Subject: Transmittal of Revision 1 To Service Bulletin Number
V25000-ENG-72-0368.

International Aero Engines SERVICE BULLETIN

ENGINE - PROVIDE NEW 2ND STAGE HIGH PRESSURE TURBINE (HPT) VANES

V2500-ENG-72-0368

Location of the Stage 2 High Pressure Turbine (HPT) Vane Assemblies
Figure 1

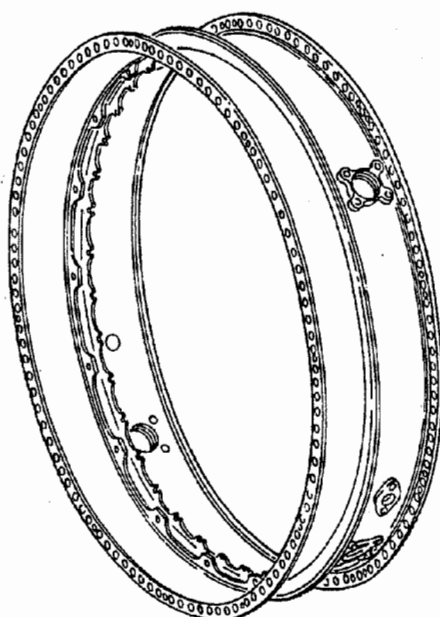
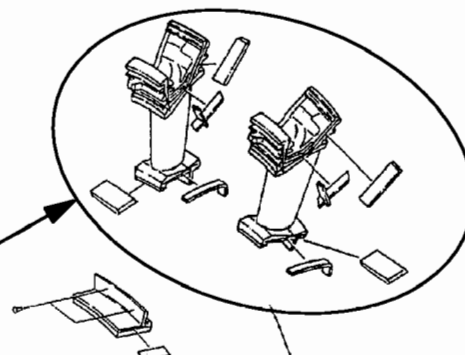
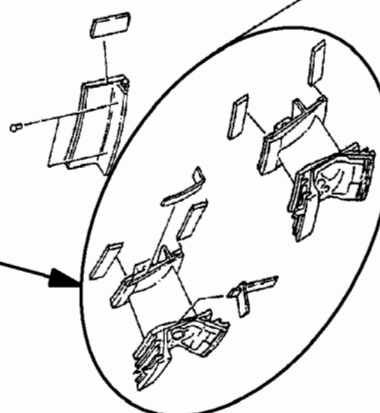
INSTALL THE 2A3572
STAGE 2 HIGH PRESSURE
TURBINE VANE ASSEMBLY
(2 off)*

INSTALL THE 2A3572 AND
2A3282 STAGE 2 HIGH
PRESSURE TURBINE
VANE ASSEMBLIES (1 off)

- A. Replace the 2A3402 Stage 2 HPT Vane Assembly (2 off) with the 2A3572 Stage 2 HPT Vane Assembly when you assemble the new Stage 2 HPT Ring Segment and Vane Cluster Assembly by the procedure specified in Reference 2, Chapter/Section 72-45-24.

- B. Replace the 2A3302 and 2A3402 Stage 2 HPT Vane Assemblies (1 off) with the 2A3282 and 2A3572 Stage 2 HPT Vane Assemblies respectively when you assemble the new Stage 2 HPT Ring Segment and Vane Cluster Assembly by the procedure specified in Reference 2, Chapter/Section 72-45-24.

Family Tree - Stage 2 High Pressure Turbine Vane Assembly
Ref. Catalog Sequence No 72-45-24. Fig. 02 Item 420
Figure 3

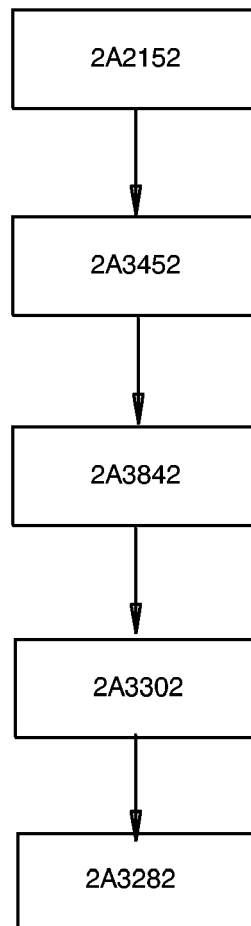
V2500-ENG-72-0368
ENGINE - PROVIDE NEW
2NDSTAGE HIGH PRESSURE
TURBINE (HPT) VANES

PART NUMBER CHANGE
